Re: Request for Records
Freedom of Information and Protection of Privacy Act

VDZ-VIDAL ST.

DEVELOPMENT PROPOSAL APPLICATION – COMMENT SHEET

1 TREE PROTECTION AND REMOVAL PLAN
 Scale 1:250

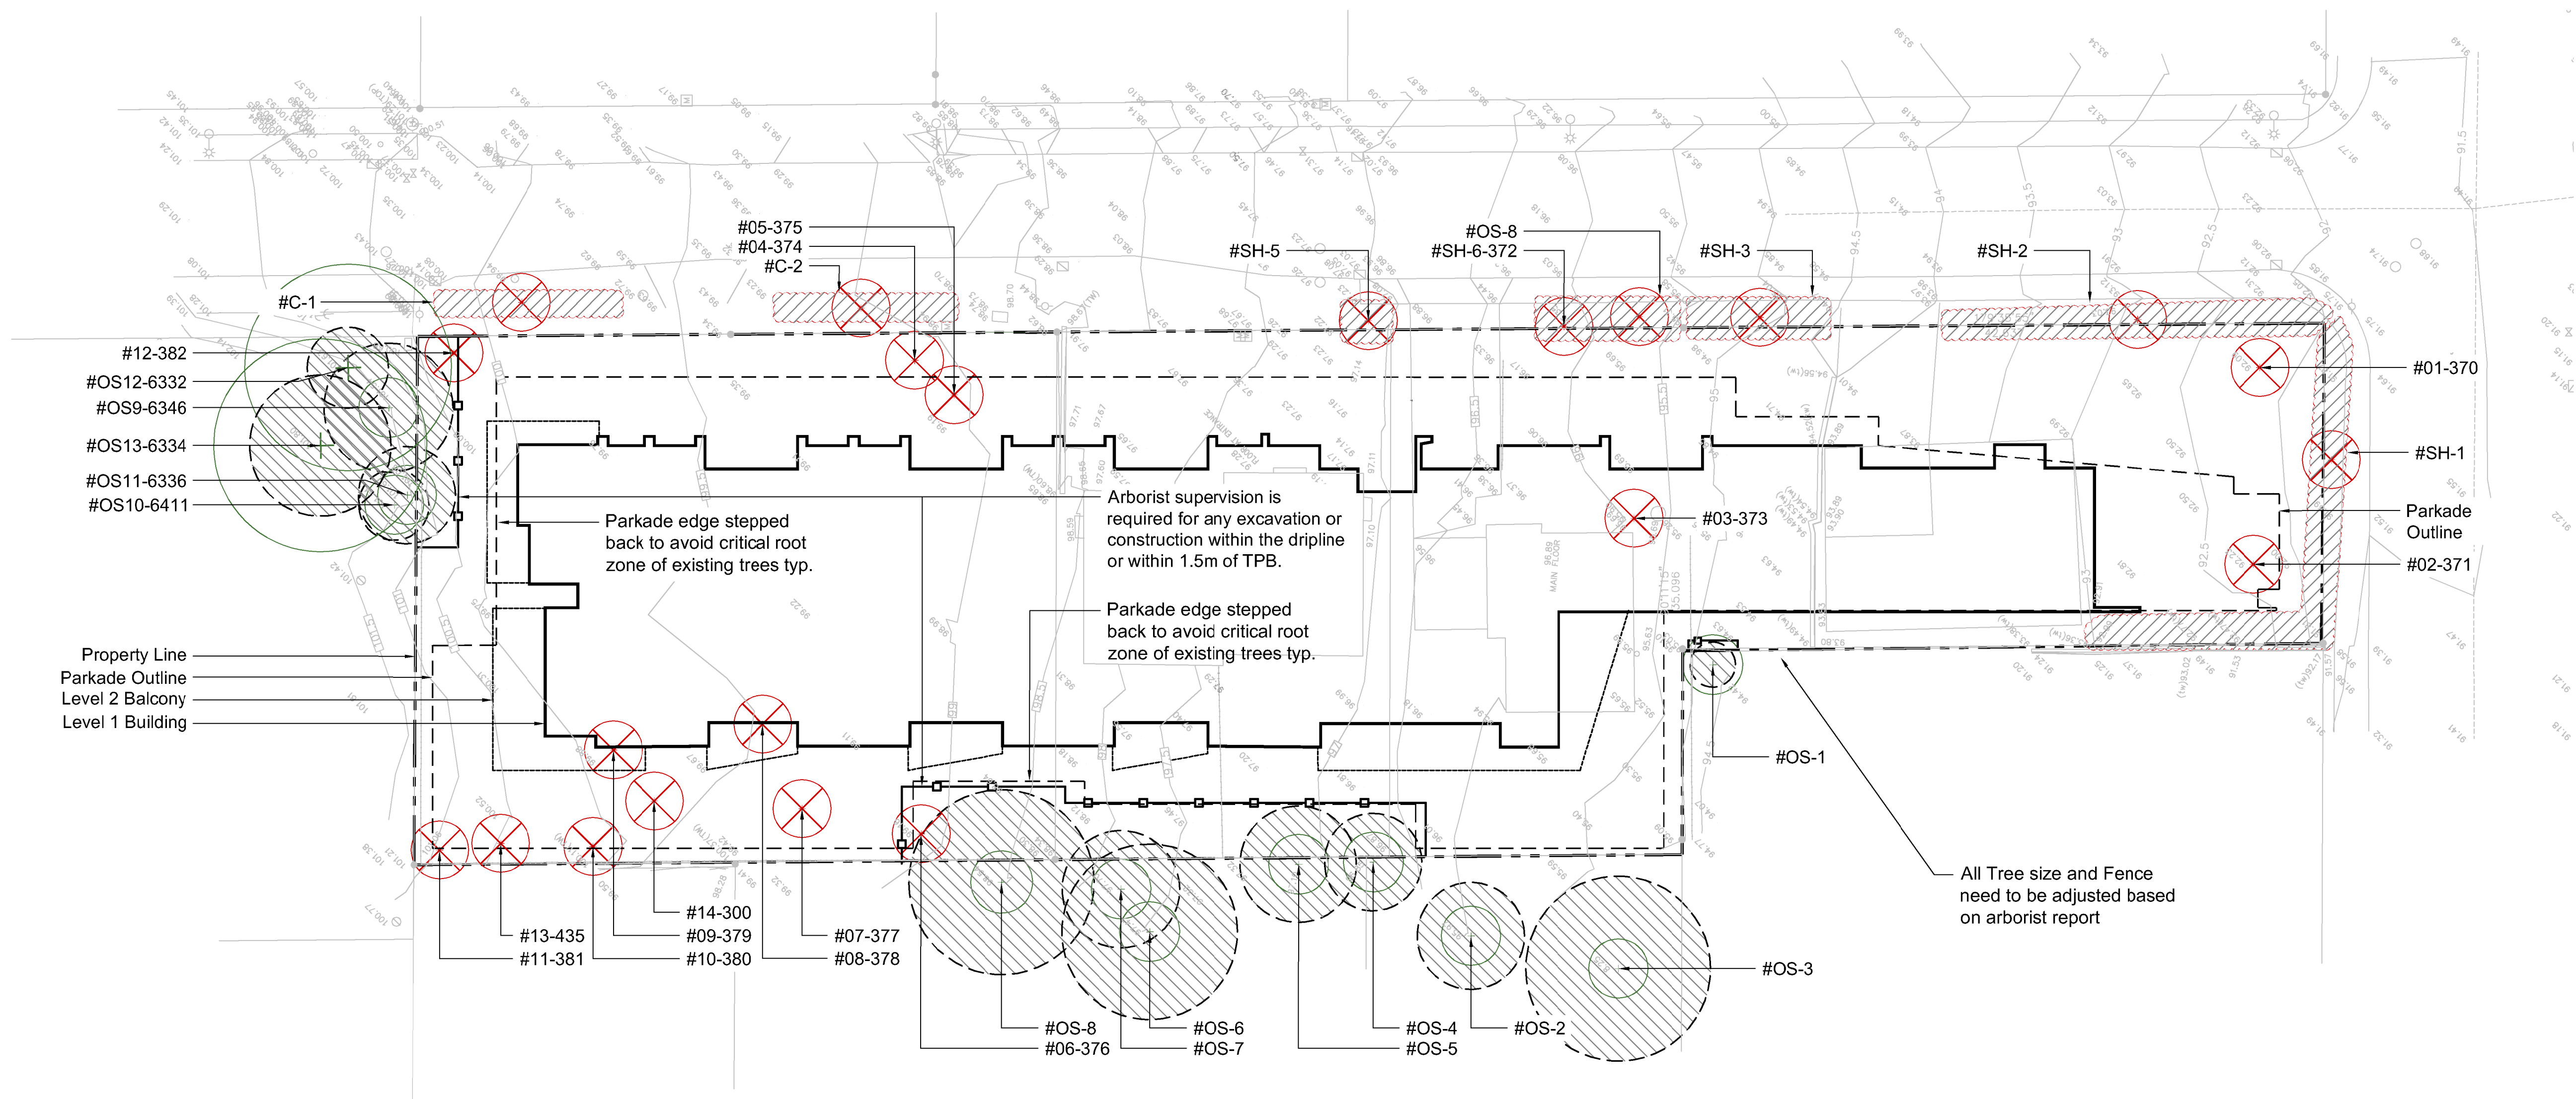
DEPARTMENT	Landscaping Plan
COMMENTS:	
<p>Page L-02 shall include the following language:</p> <p>Tree Protection Notes:</p> <ol style="list-style-type: none"> 1. All work around protected trees to be conducted as per municipal Tree Management Permit and Bylaws. 2. ALL work within the tree protection zone is to be approved and supervised by on site certified arborist. 3. Monthly inspections and follow up memo style reports are to be submitted to the City of White Rock for the preservation of offsite significant trees.

The revised arborist report still says the offsite large trees have been handplotted as the property legal survey from 2018 has not included all of OS3-OS8 Douglas fir trees. It is required and prudent to demonstrate the exact percentage of roots protected or potentially calculated for loss when revising the plans.

Tree 1 (#OS-3):

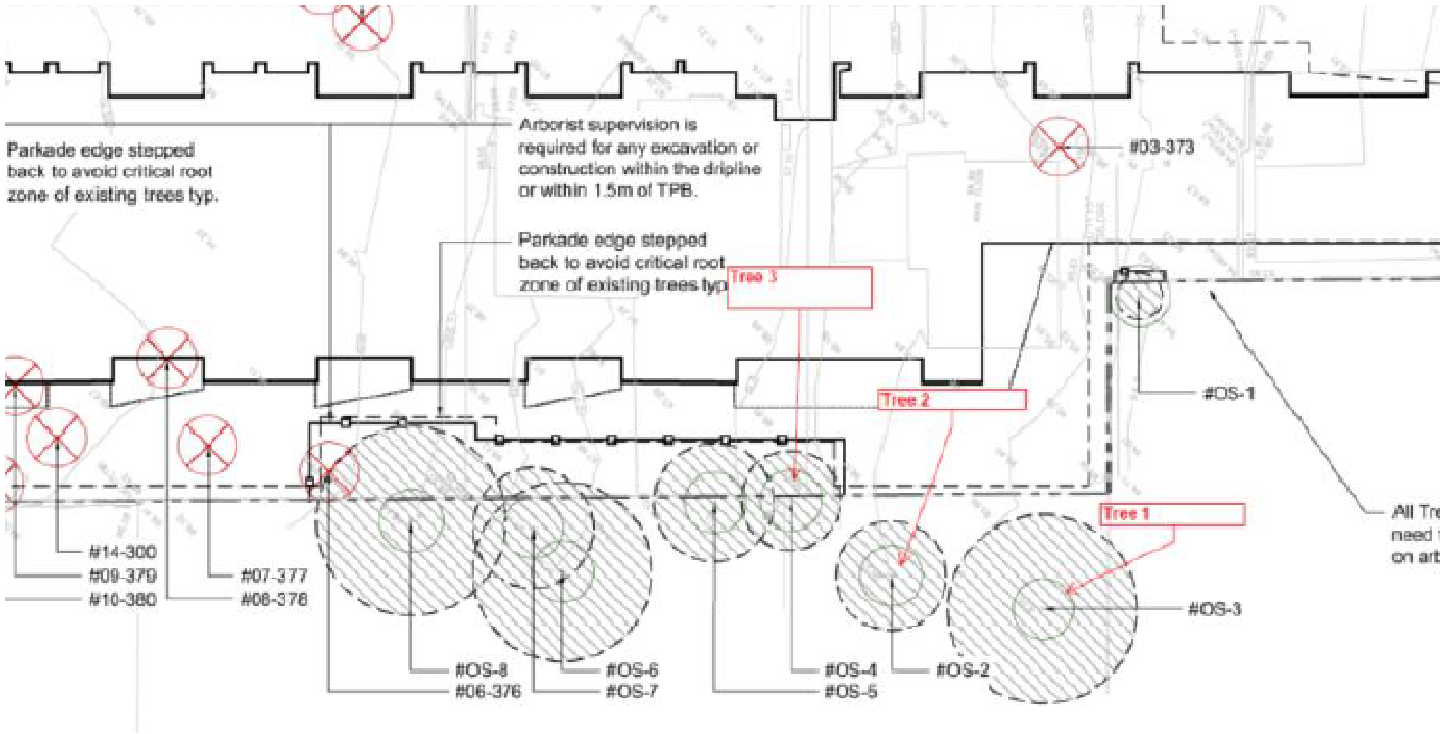
Comment from your letter:

- This tree is included in the Arborist report and shown on the TMP as #OS-3, and the Critical Root Zone (CRZ) is noted (Fig. 1).

- This tree is included in the Arborist report and shown on the Tree Management Plan as #OS-2. (Fig. 1, 2, 4). Root mapping with radar has been done for this tree and the results support using 6x trunk diameter at 1.4 m to determine the CRZ. The Tree Management Plan shows this Critical Root Zone (CRZ).

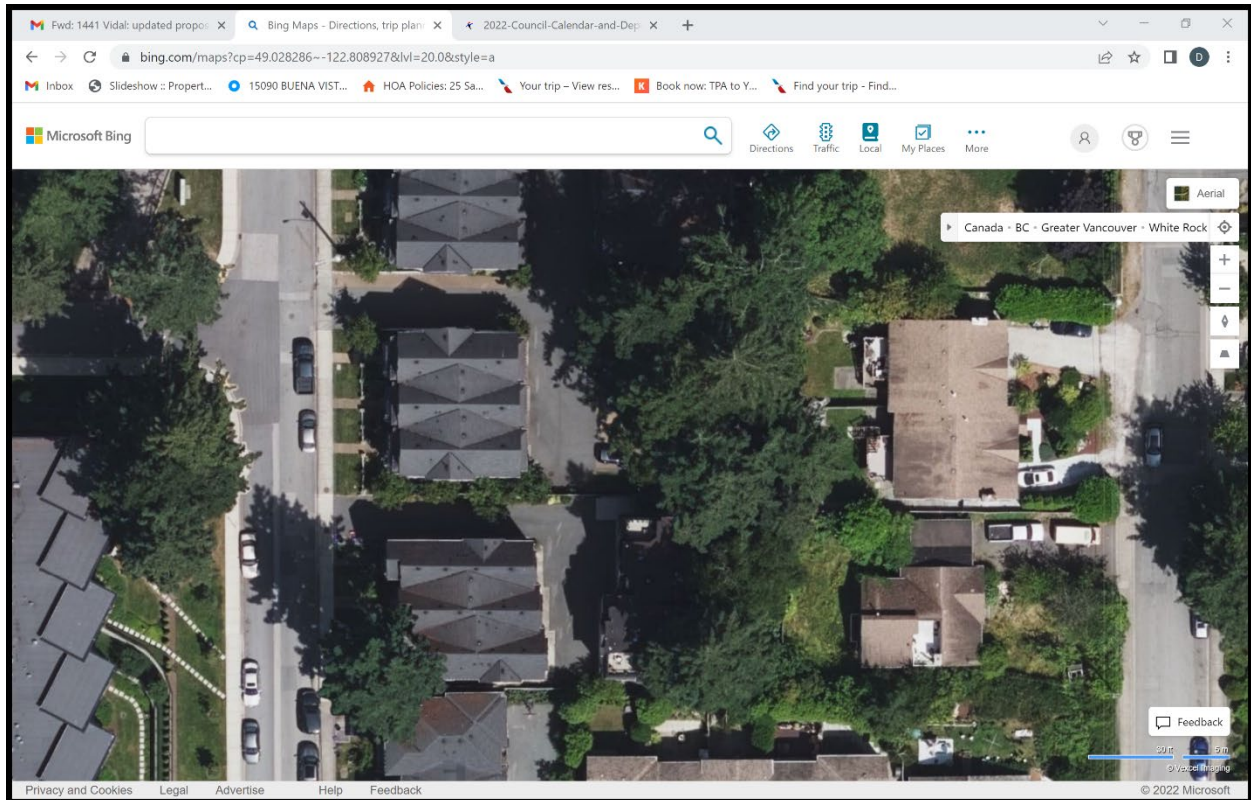
Tree 3 is one of a cluster of Douglas Firs. Only a part of this cluster of trees is shown on the reports that I have seen, and I think the omission (assuming this has not been remedied) means that the extent of the grove that is competing for water in the area is understated. When that report is issued, I will be checking to make sure that it meets the requirements of the Tree Protection Bylaw by showing all offsite trees within 4 metres. For now, I will simply report that the dripline for Tree 3 extends well into the development lot and unlike for the trees to the north, the notch of the parkade ends too soon to allow for the 1 metre of clearance beyond the drip line of this tree on the south side.

I am inserting a screenshot from Bing maps which shows the overhang onto the development lot all along the back fence **Redacted S. 22**

These trees are protected trees under the White Rock Tree Protection Bylaw.

The critical root zone for each of these trees extends into the area shown as parkade in the drawings.

1 SECTION AT OFF-SITE TREE OS10 AND OS11
 Scale 1:50

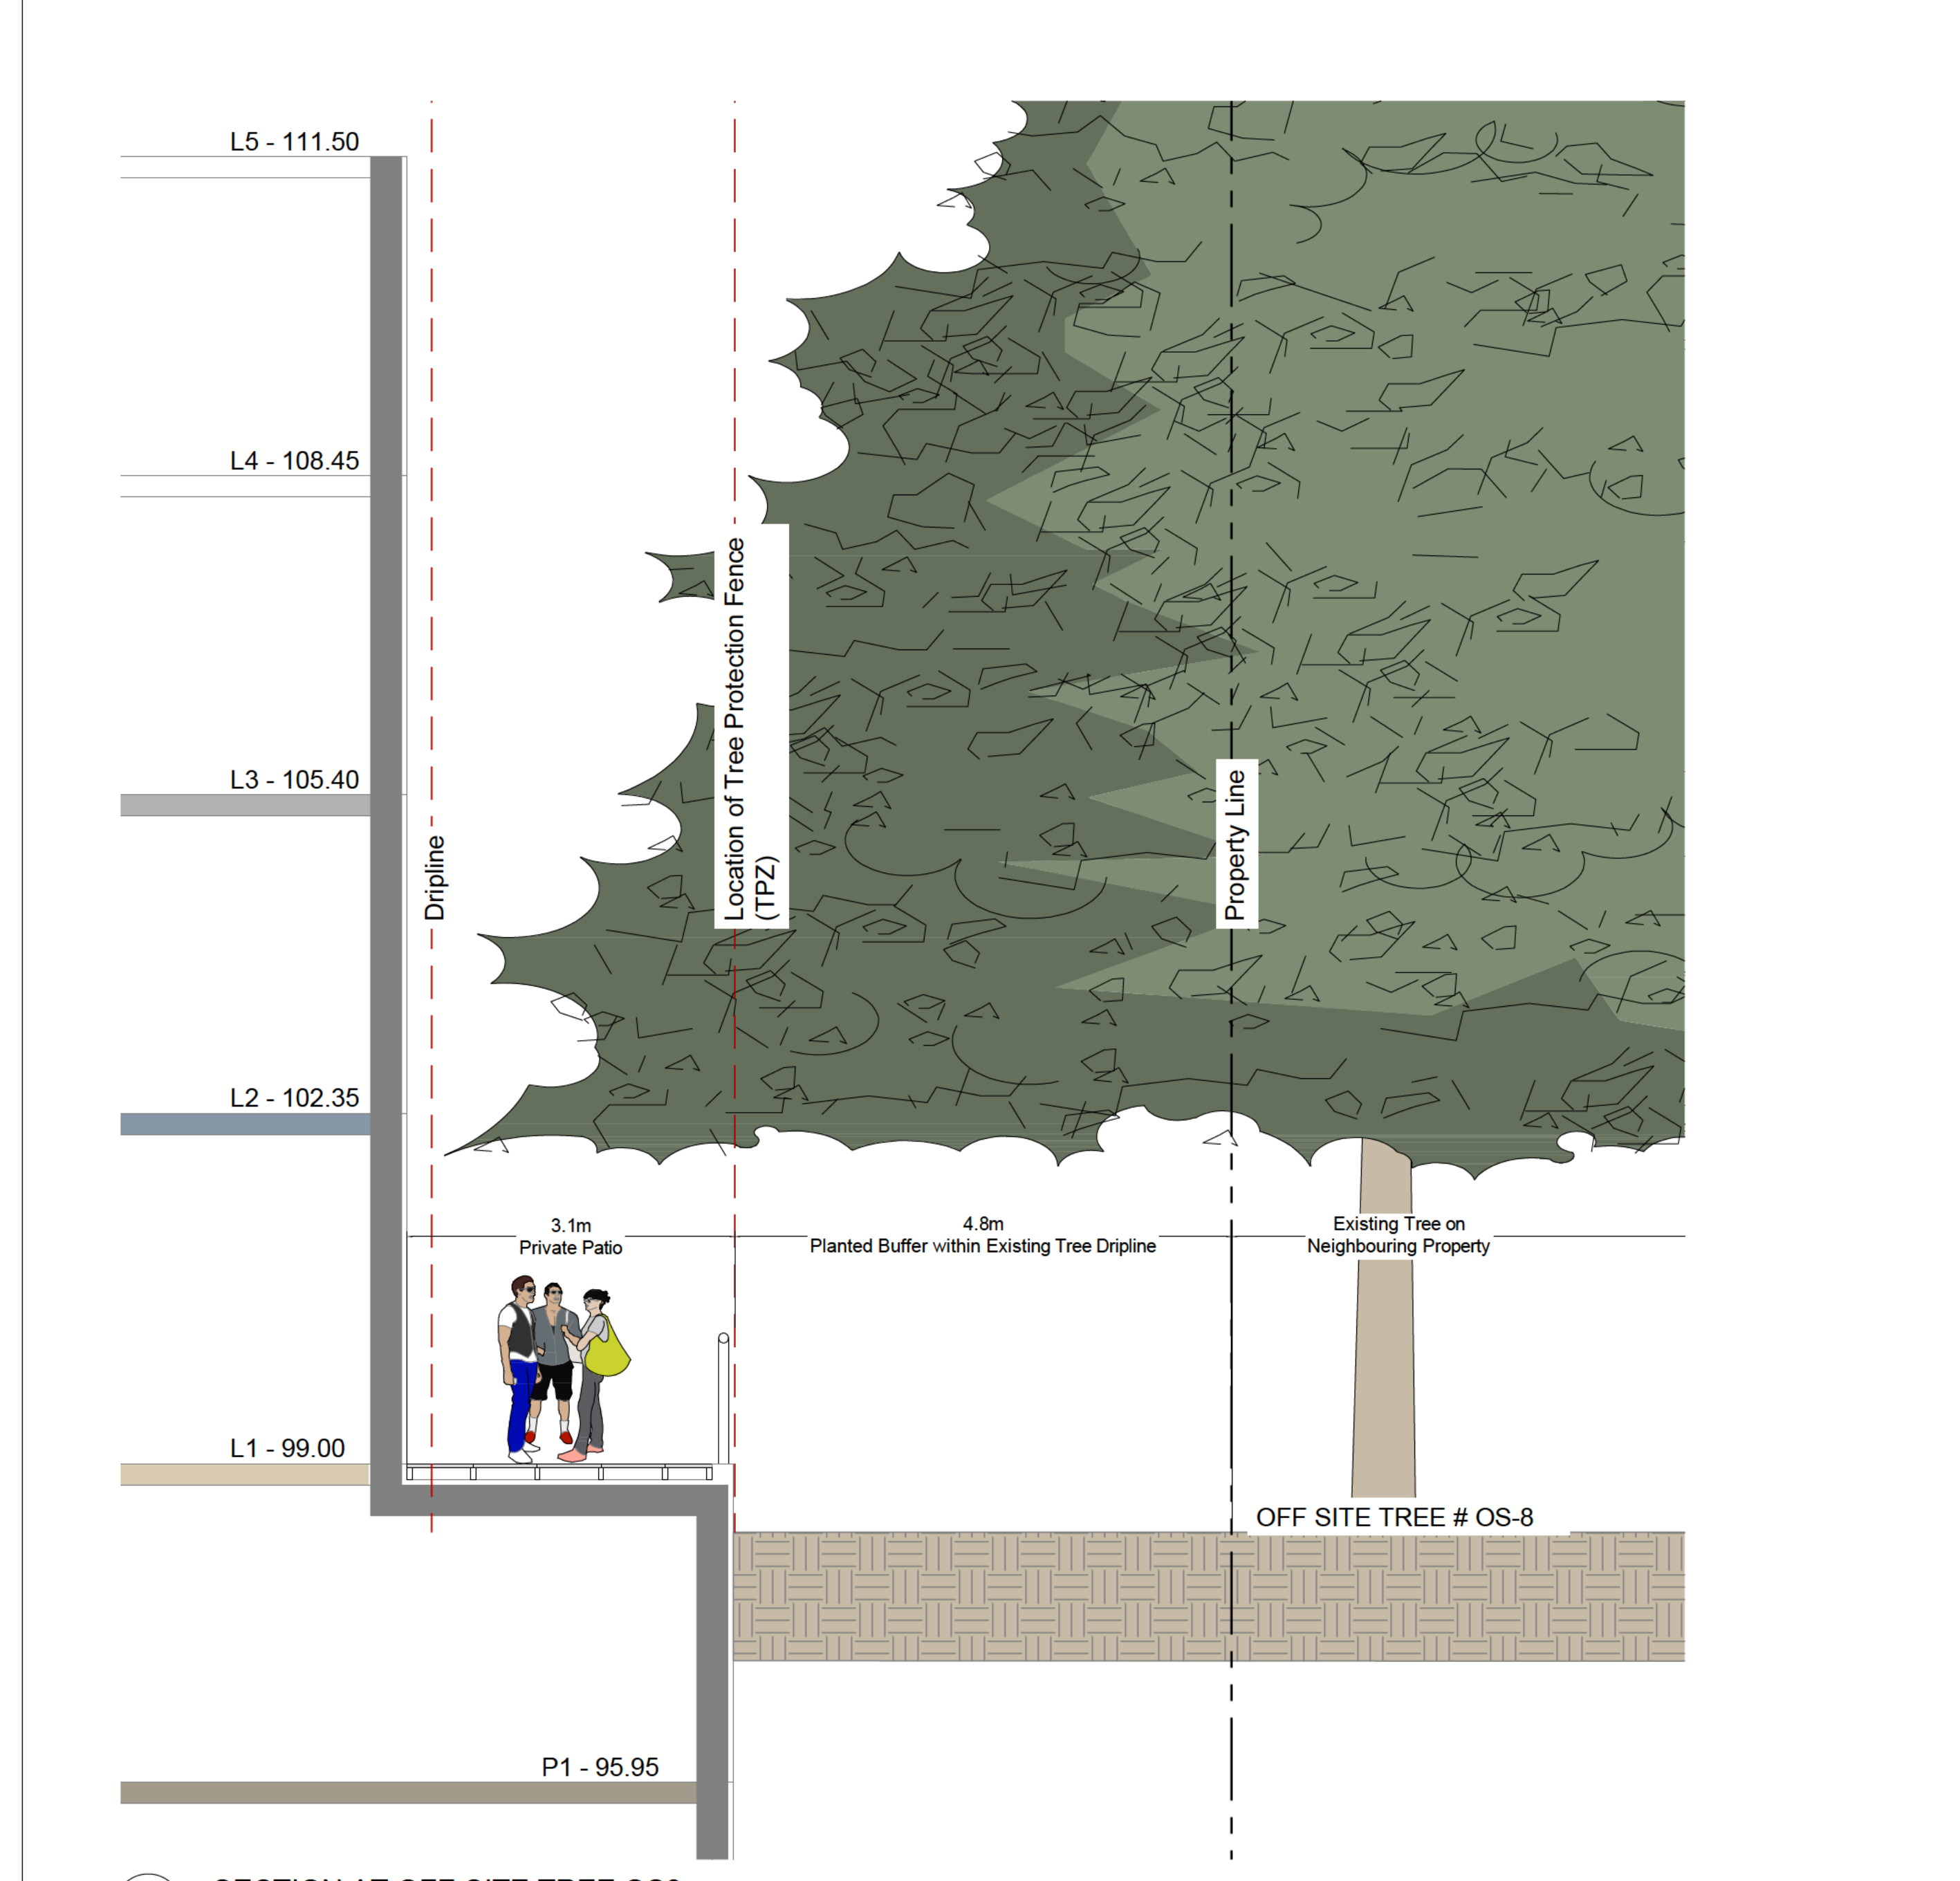
As there are off-site trees with driplines that extend into the subject property, there may be interconnected root systems within the grouping (OS9-OS11) which likely extend onto the property. BC Plant Health Care Root Radar results determined the roots of tree 06 has poor structure and multiple trunks with decay. In addition, OS2-OS6 have feeder or structural roots which grow towards the property. Any work done within the critical root zone will need to be monitored by the arborist. Any retention wall should be maintained to avoid root disruption and destabilization.

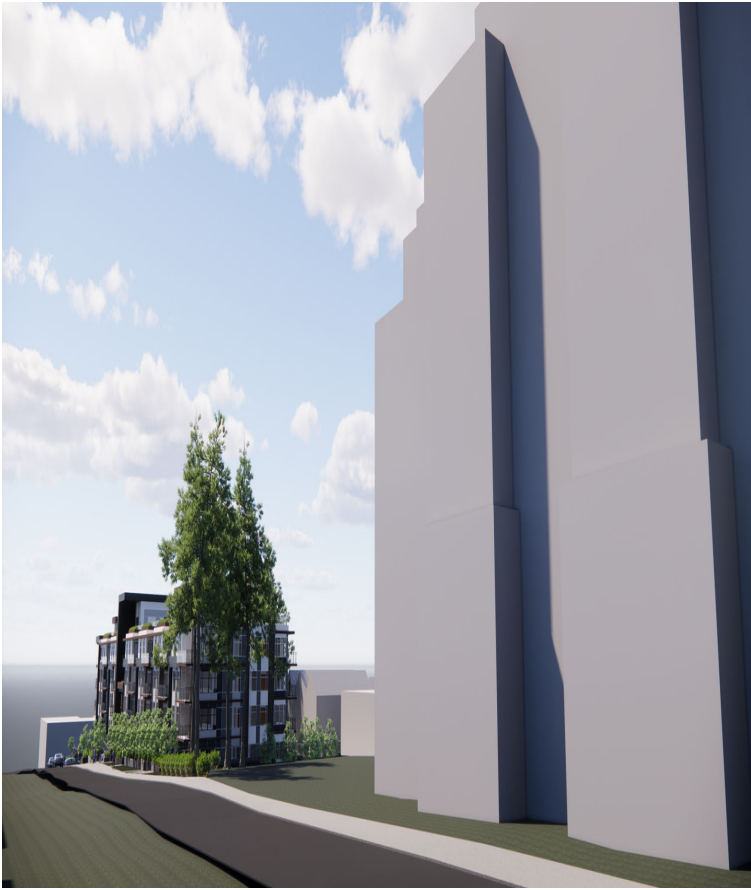
What is the height of the building at the half way point down Vidal on the East side.

The height at the midpoint on the east side facing Vidal is 14.38m (47'-2 1/4") @ the low roof, 19.46m (63'-10 1/8") @ the high side of the lobby and 20.06m (65'-9 3/4") @ the low side of the lobby
